# Sheringham Shoal and Dudgeon Offshore Wind Farm Extension Projects

Outline Operational Drainage Strategy (Revision C)  
(Tracked)

## Revision C

Document Reference: 9.20.1

Project:	SHERINGHAM SHOAL & DUDGEON WINDFARM ONSHORE CABLE FEED	
Revision:	F04	Dwg Title: SUBSTATION OUTLINE DRAINAGE STRATEGY INFILTRATION METHOD
Scale:	1:2000	Dwg No: C282-MU-Z-XD-00118-01
Sheets:	1 OF 1	Purpose of Issue: FOR INFORMATION
Internal Proj Ref:	1002-000591	Client Ref Number: -

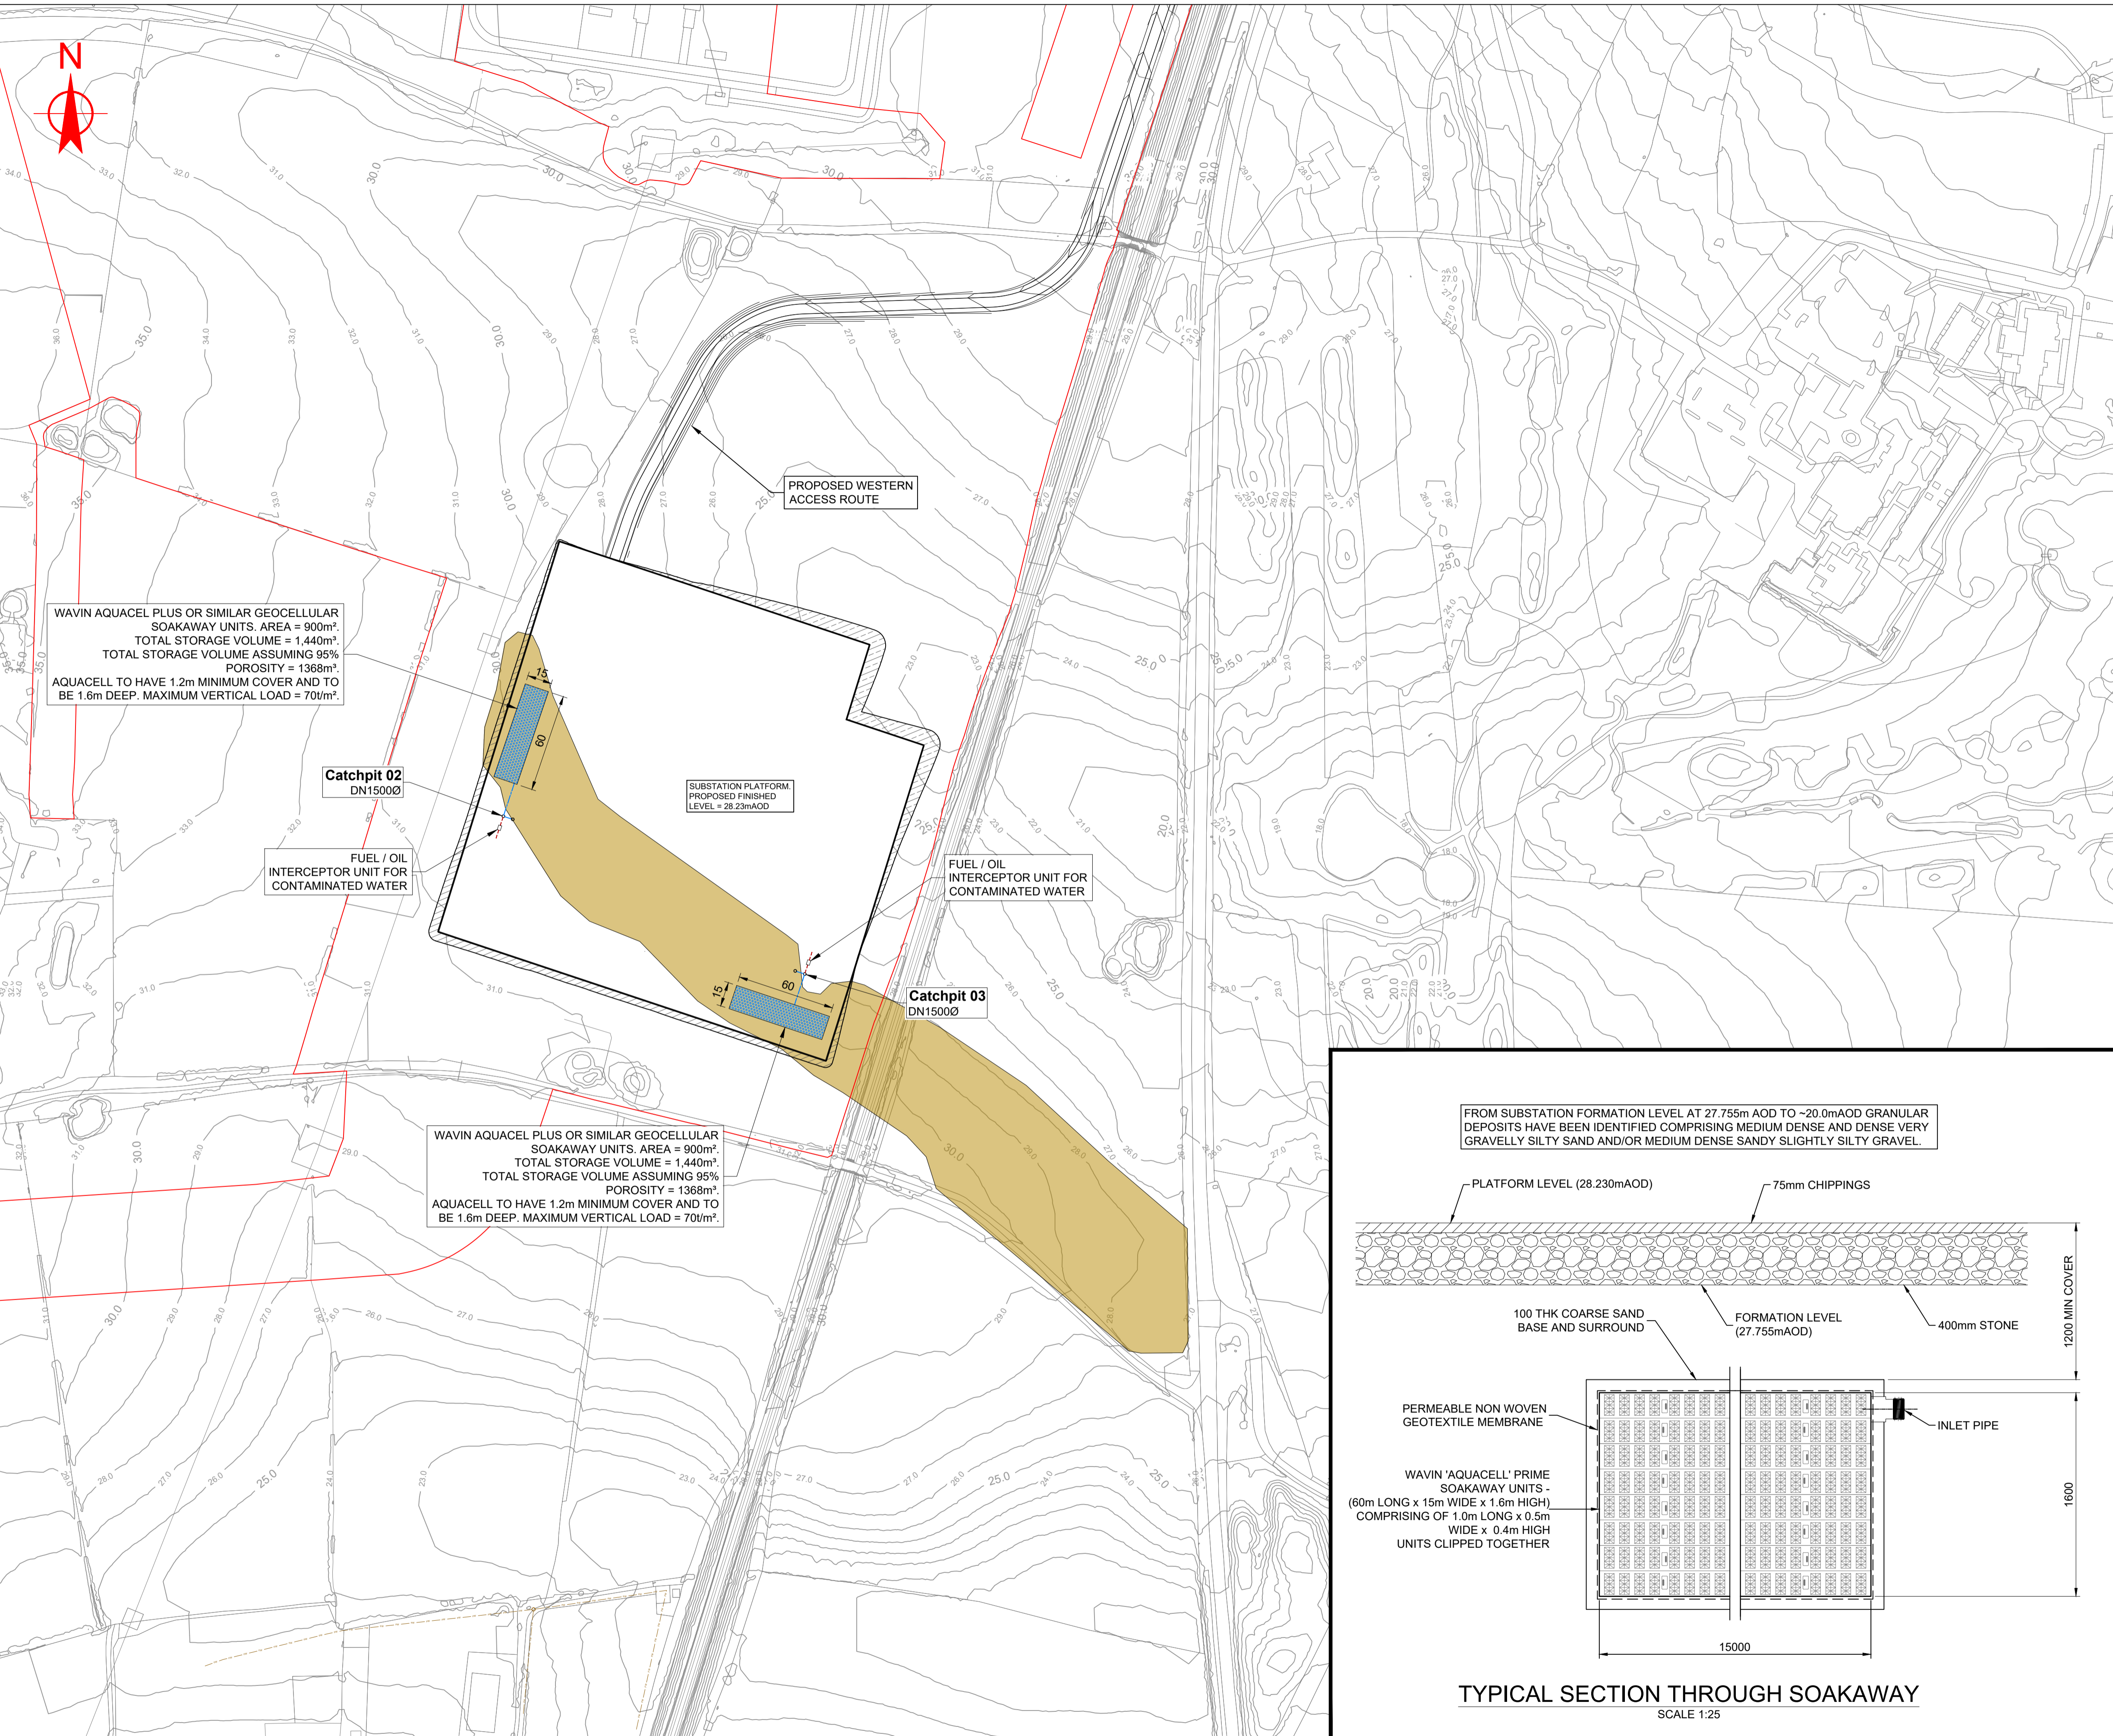
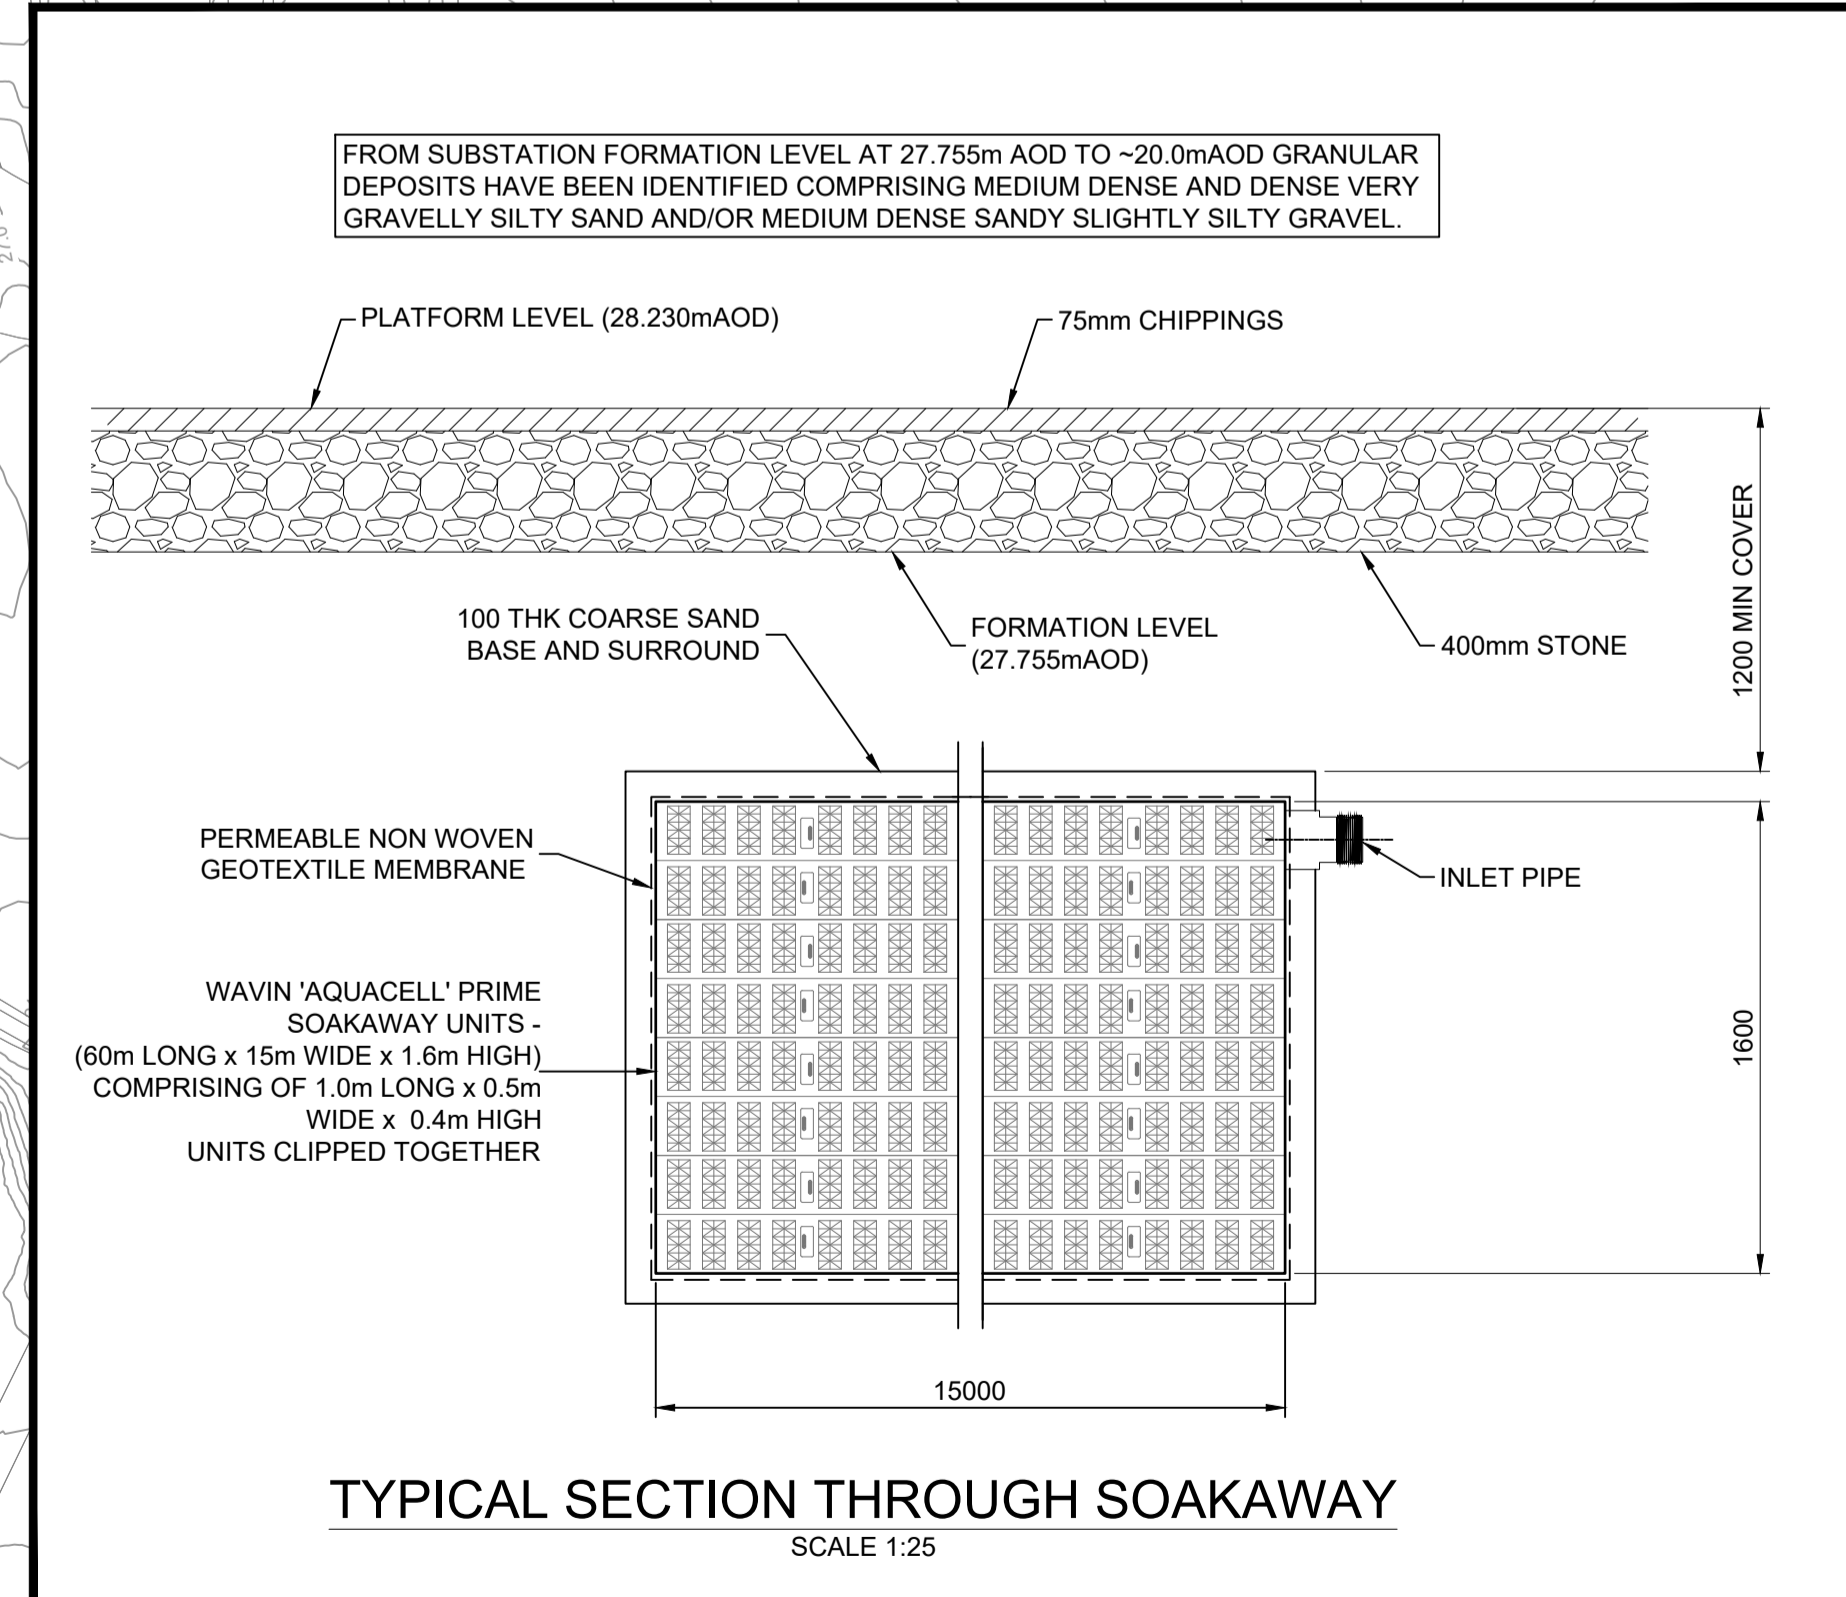
20. A soakaway design has been developed which indicates two 60m long x 15m wide x 1.6m deep soakaways with a total storage volume per soakaway of  $1,368 \text{m}^3$  assuming 95% porosity. A total storage volume  $2,736 \text{m}^3$  at 95% porosity has been provided, as depicted on drawing C282-MU-Z-XD-00118-01 F04 included in Appendix B.

26. For the worst case 480min winter storm a soakaway storage volume of 1,192.7m<sup>3</sup> per soakaway is indicated to be required which confirms that each soakaway shown on drawing C282-MU-Z-XD-00118-01\_F04 included in Appendix B is oversized by 175m<sup>3</sup> giving a total site storage 350m<sup>3</sup> greater than required. Please refer to Appendix A for the MicroDrainage verification calculations soakaway volume calculation

REV	DRAWN	CHK	APP.	DATE	REVISION COMMENTS
F04	A.LISIKOW	M.PERKINS	J.CURRAN	26/04/23	MINOR CHANGES TO SOAKAWAY VOLUME TEXT
F03	S.LYONS	M.PERKINS	J.CURRAN	28/02/23	SOAKAWAY AREA INCREASED IN LINE WITH MICRODRAINAGE VALIDATION
F02	L.EDGE	M.PERKINS	J.CURRAN	27/07/22	SOAKAWAY DETAILS ADDED
F01	S.LYONS	M.PERKINS	J.CURRAN	01/07/22	ISSUED FOR INFORMATION
